Marion County Subdivision Plat Review

Plat Title: River Gorge Ranch Phase 2 Final Plat

Date of Review	Reviewed by	Planning Staff
August 24, 2023	Ashley Gates	Renea Wilson

Marion County, Tennessee

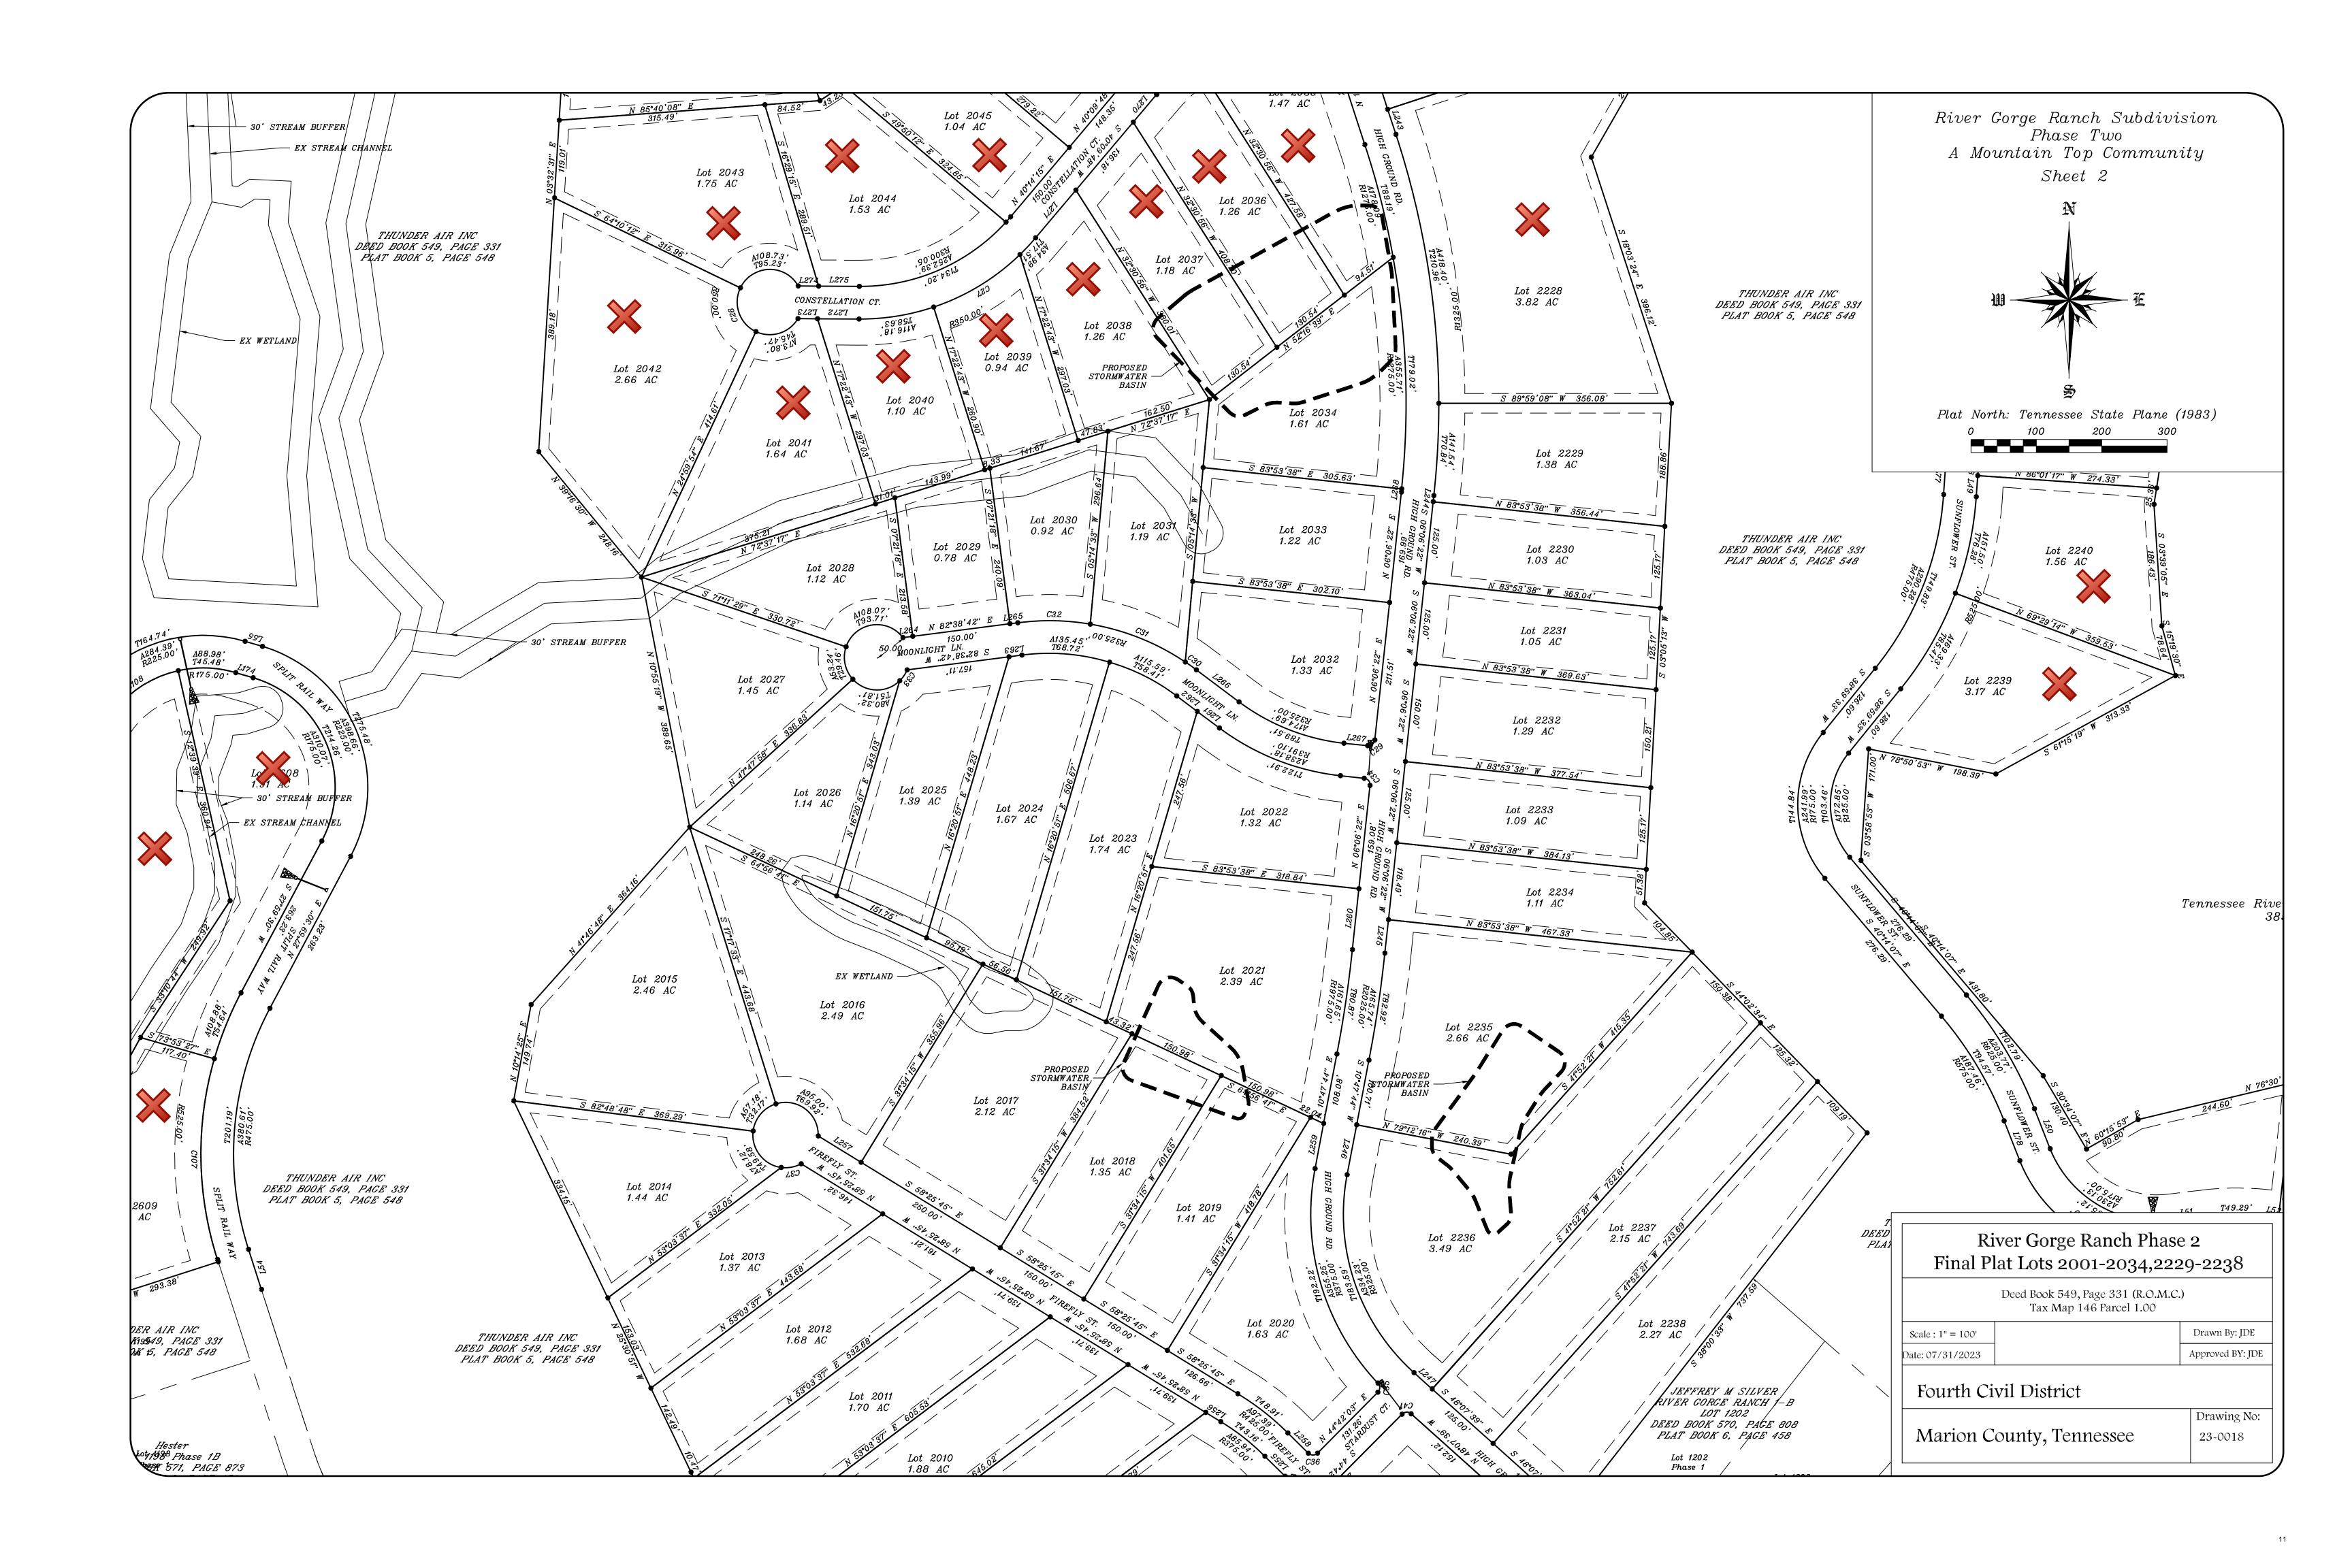
- Minimum Width: 75 feet at the setback line. All lots appear to meet this requirement.
- Minimum Depth: All lots appear to meet this requirement.
- Depth to width ratio: Depth must not exceed 5 times the width. Lot 2237 does not appear to meet this requirement. The Planning Commission may approve these lots if they find there are "unusual circumstances that make these limitations impractical." Approval of this plat constitutes approval of Lot 2237 as submitted. A separate motion is not required.

- Street Names: Appear to be High Ground Road, Moonlight Lane, Constellation Court, Firefly Street, and Stardust Court. Moonlight Lane is already in use within Jasper Highlands. Firefly Court is also in use in Jasper Highlands, which is similar to Firefly Street but not the same. Though they are different ZIP codes, staff recommends against repeating road names. Many who call 911 do not know which ZIP code they are currently in. The Planning Commission approves street names through plat approval, and may require changes.
- Right-of-Way width: Measurements were not provided, but based on spot checking by staff ROW appears to meet 50' minimum width for local streets and 50' radius requirement for cul-de-sacs.

- Temporary cul-de-sacs: No temporary cul-de-sacs are shown. Temporary cul-de-sacs are required at the end of any dead end streets.
- Horizontal Curves: Horizontal Curves must have a minimum centerline radius of 100 feet. No
 measurements are provided for centerline curves as required for final plats. Staff measurements
 indicate that all horizontal curves in this portion of Phase 2 exceed the minimum centerline radius.

- Tangents: Between reverse curves, a 100-foot tangent is required. The tangent between reverse curves on Moonlight Lane is not adequate.
- Vertical Curves: Vertical curves must provide a sight distance of 200 feet. Additional information for the vertical curve near Station 59 on High Ground Road is needed to ensure this requirement is met. All other vertical curves appear to meet this requirement based on the vertical profiles provided to staff.

Stormwater basins are shown on the final plat. No additional information regarding the drainage system is provided. Staff cannot assess compliance with this section of the Subdivision Regulations. Several roads exceed the grade limits listed requiring 3,000 PSI cement concrete.

- Differentiate between the lots that are intended to be platted and those that are not. Having them listed in the title is not adequate. Several lots are shown that are not listed in the plat title. Staff has not reviewed lots other than those listed in the title.

- List book and page number for any restrictive covenants that have been recorded.
- List all requested variances
- Select a different street name for Moonlight Lane

- Show temporary cul-de-sacs at dead end of High Ground Road
- Adjust Moonlight Lane to meet the required minimum tangent between reverse curves
- · Show road centerline with all required measurements

- Drainage easements should be listed or shown on plat
- Provide planning staff or Marion County Highway Superintendent with drainage plans so that compliance with Section 601 of the Subdivision Regulations can be reviewed.
